**AGENDA**  
**Planning & Zoning Commission**  
**Regular Meeting**  
**San Luis Council Chambers**  
**1090 E. Union Street**  
**San Luis, AZ 85349**  
**Tuesday, August 13, 2024**  
**6:00 P.M.**

## PLANNING & ZONING AGENDA ITEM REVIEW FORM

# BIENESTAR ESTATES 12 - PHASE 2 SUBDIVISION

# ORCHIDEA PARK PHASE 1

# ORCHIDEA PARK PHASE 1 SUBDIVISION

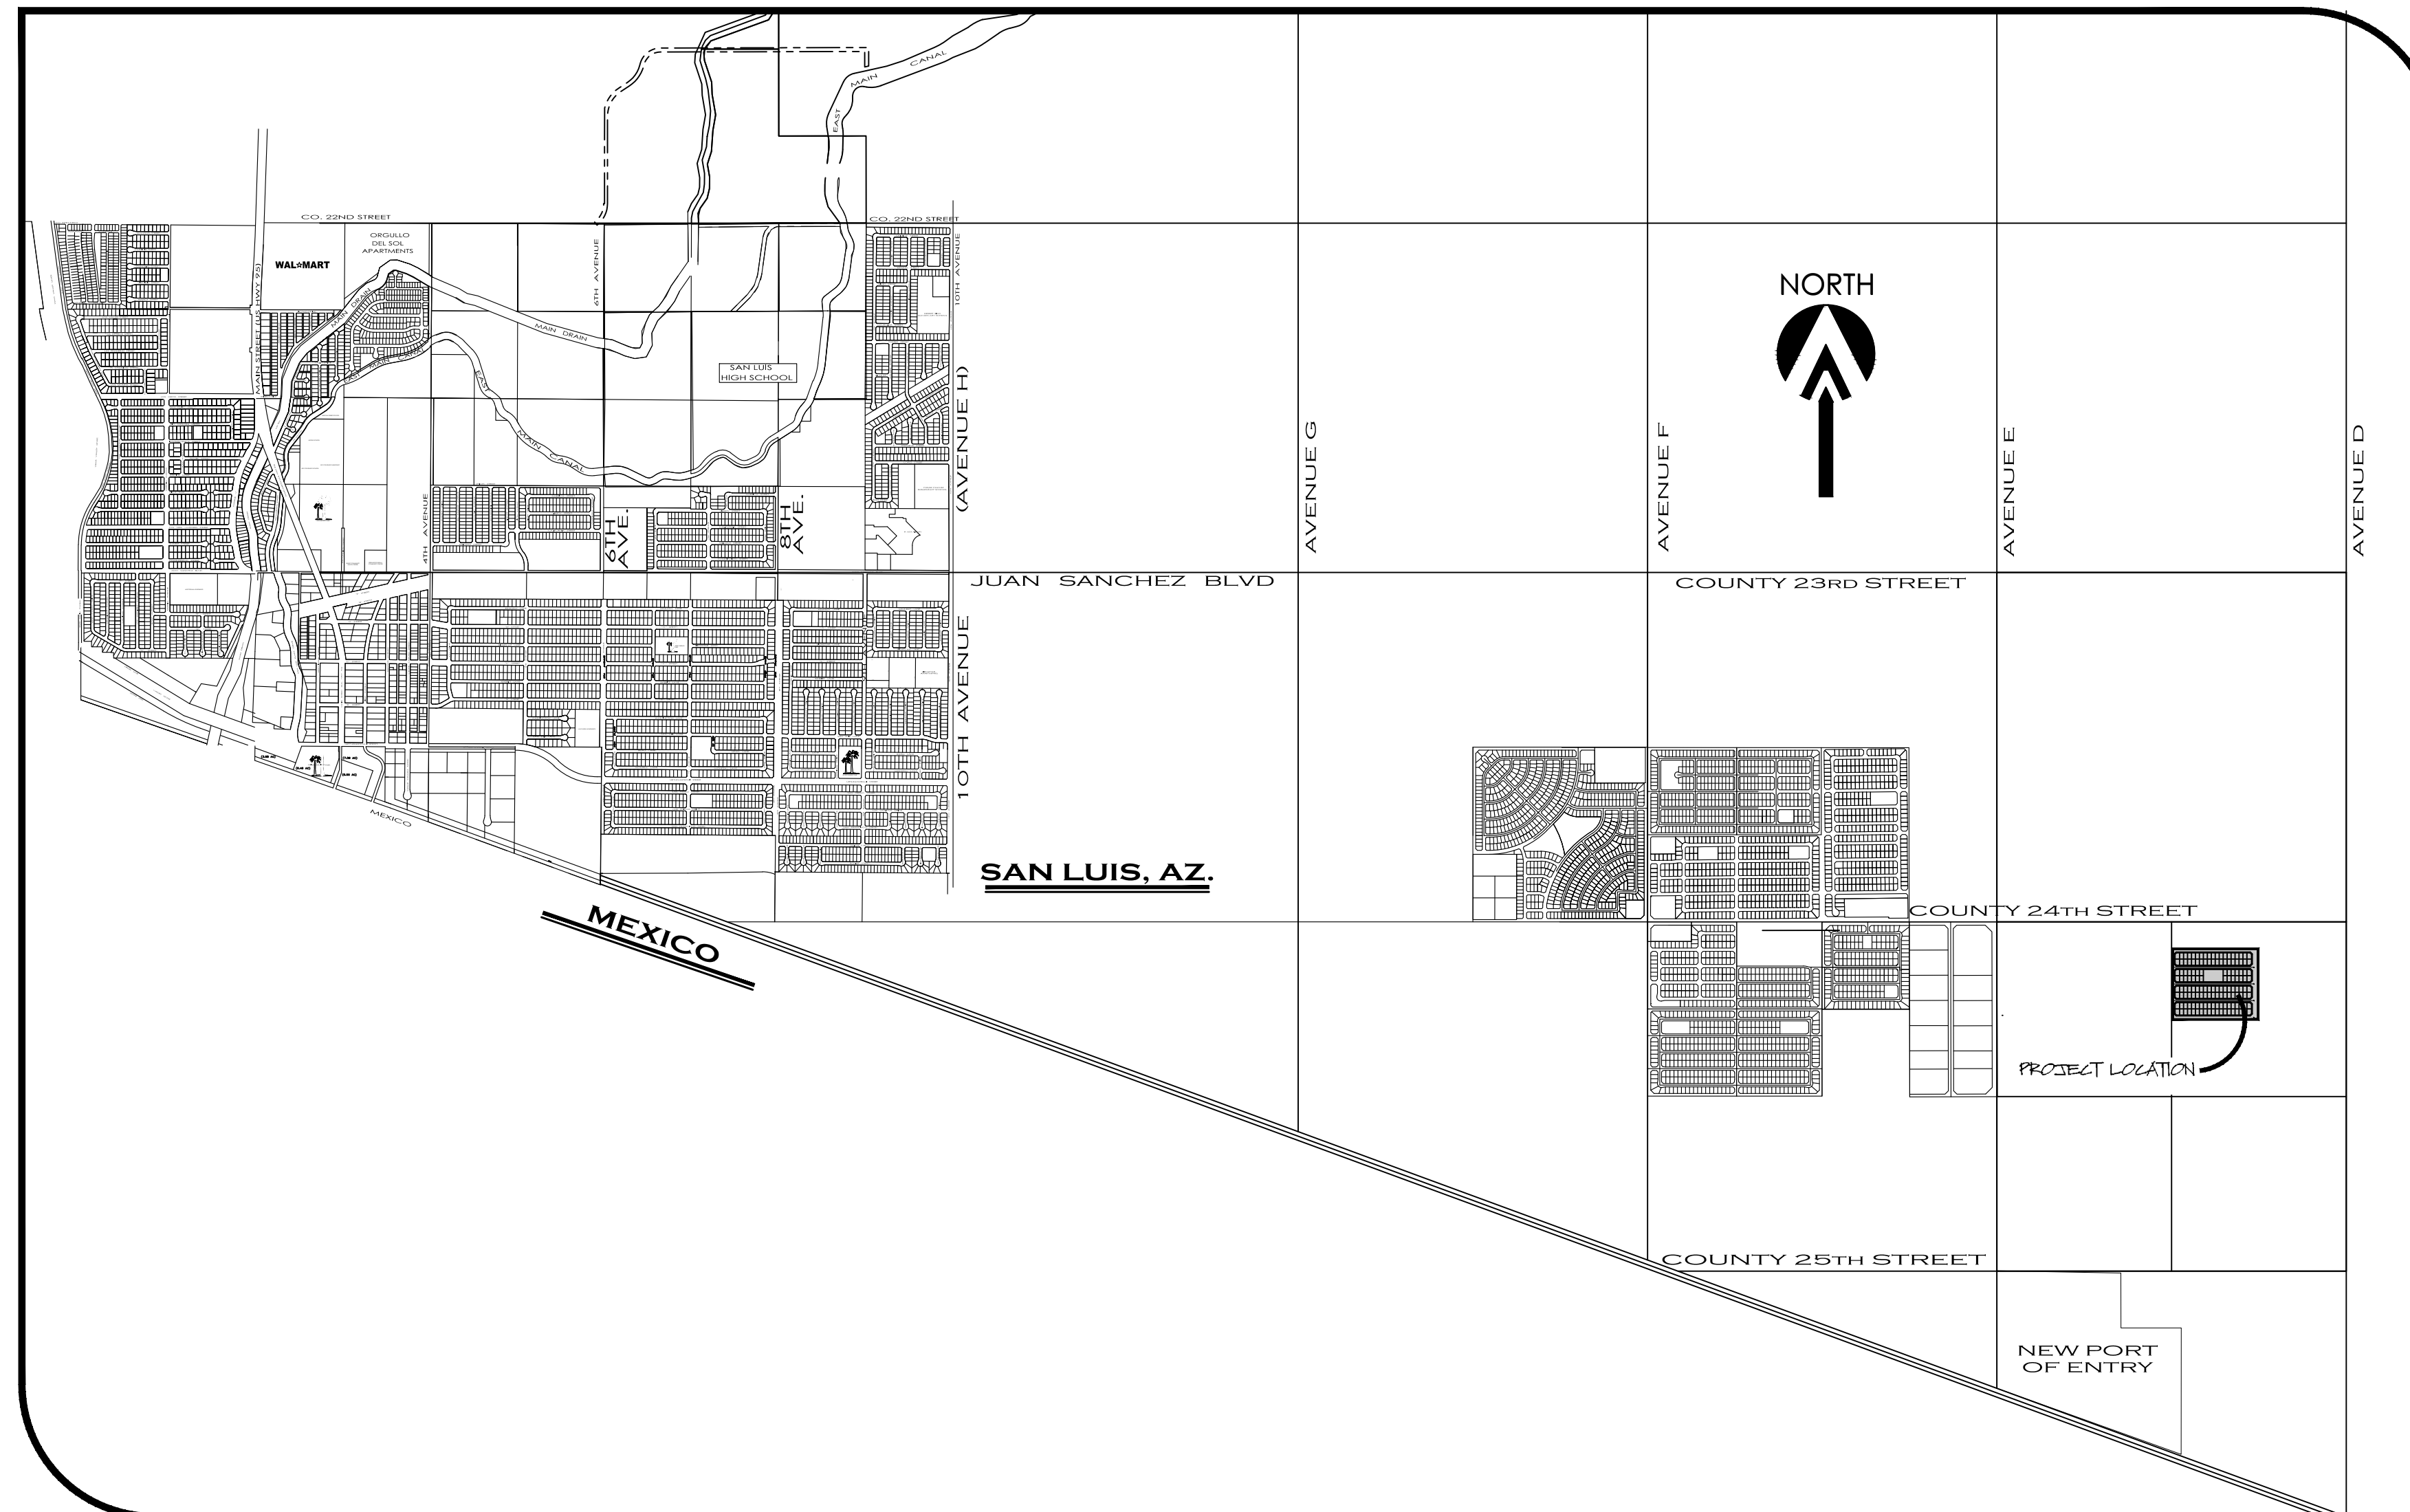
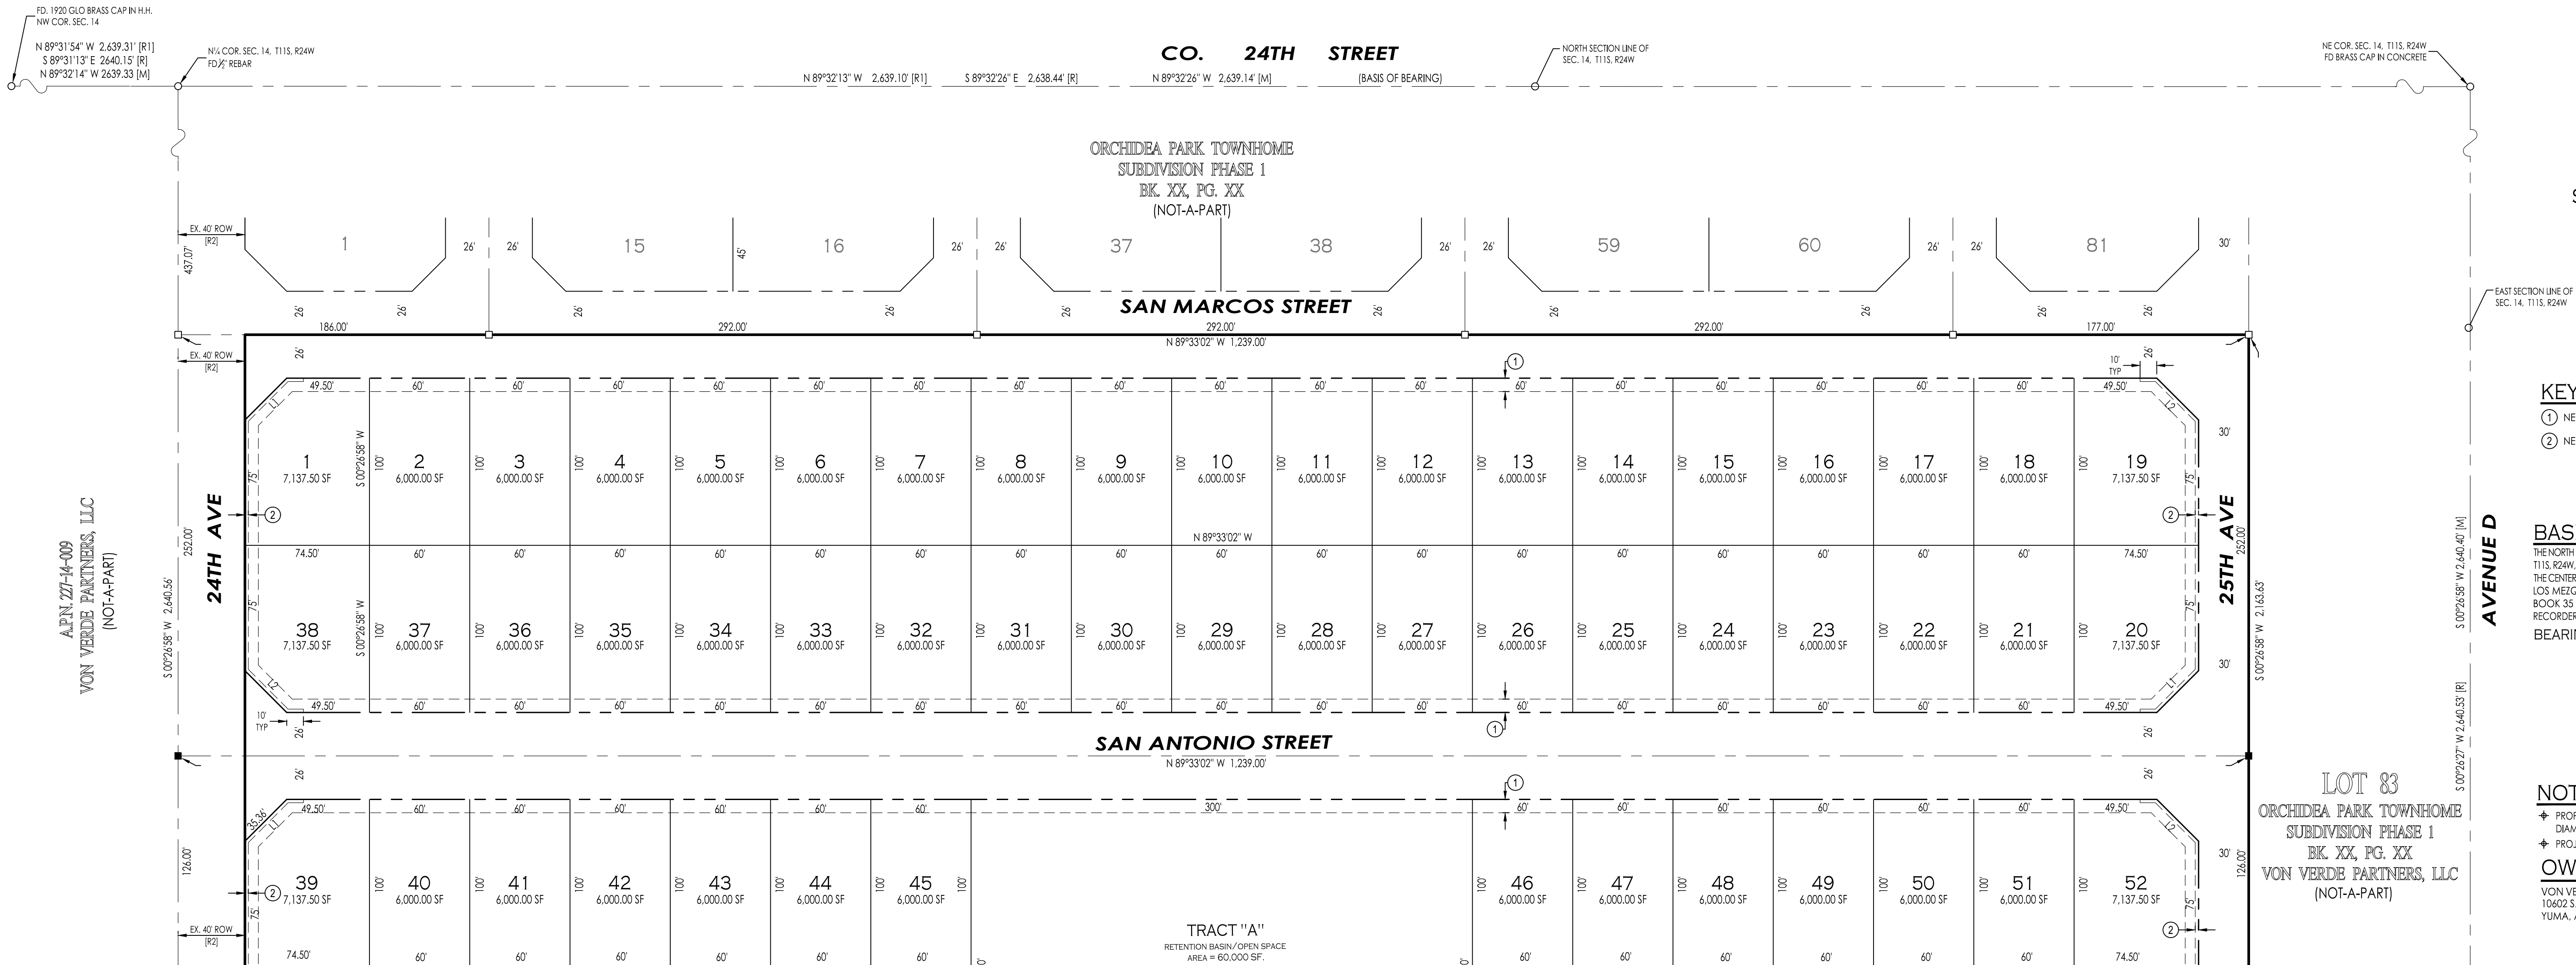
1. Provide CCR's and Title Report.
2. On Approved Section revise "Director of Planning and Zoning" to "*Director of Development Services*".
3. Add 1' NAE to lots that abut retention basin.
4. Legend - Reference survey monuments to COY standards.
5. As per current Subdivision Regulations subdivider will take such actions as may be necessary to form, establish and include the subdivision in an improvement district.

1. Submit complete drainage report and engineer design report.
2. Show existing elevation contours.
3. Provide guard post location and spacing on 13' spillways.

4. Keynotes No. 5 and 9 reference detail accordingly (revise all sheets).
5. Legend - Reference survey monuments to COY standards.
6. Provide slopes and dimensioning on retention basin.

7. Provide CMU wall on lots abutting retention basin.
8. Include barricade at the end of San Marcos Street, San Antonio Street, San Diego Street, San Gabriel Street, San Fernando Street, 25<sup>th</sup> Avenue and 24<sup>th</sup> Avenue.

9. Lot 124 seems to be shallow in comparison to curb elevation, verify or clarify accordingly.
10. For 24<sup>th</sup> Avenue section to match northern developments with a centerline to curb dimensions of 26.0' and 5' sidewalk.

11. General Notes: Update notes to reference City of San Luis.
12. Provide walking pathway on retention basing (east and west side) to connect San Antonio Street and San Diego Street.

13. Provide additional lighting on retention basin for common area recreational amenities.

1. Provide ADEQ permits.
2. Add dimension from centerline to water and sewer mains.
3. Sanitary sewer manholes need to be polymer manholes as per City of San Luis Supplement to the MAG Uniform Standard Specifications.
4. Provide fire hydrant street markers as per COY Std. No. 5-160.

1. Assure design meets City of San Luis Standards. Any deviations from City Standards need City of San Luis approval prior to incorporating into the design. Update General Note No. 1 to reflect this.
2. Provide traffic study for this development and how it incorporates to proposed improvements from Mezquites and Von Verde traffic study by Nicklaus Engineering for this area.
3. As a recommendation – provide a pedestrian path be connecting the two street at the retention basin.

1. Add perimeter wall might be missing around the retention basin.
2. Include all necessary end of street barricades.
3. Suggest that CMU wall callout be modified so that the 6 foot height requirement is on the side of highest elevation.
4. The City uses dual mast arm street lights next to retention basins. Final street light design will be coordinated with APS.

1. Outlet headwall detail doesn't apply.
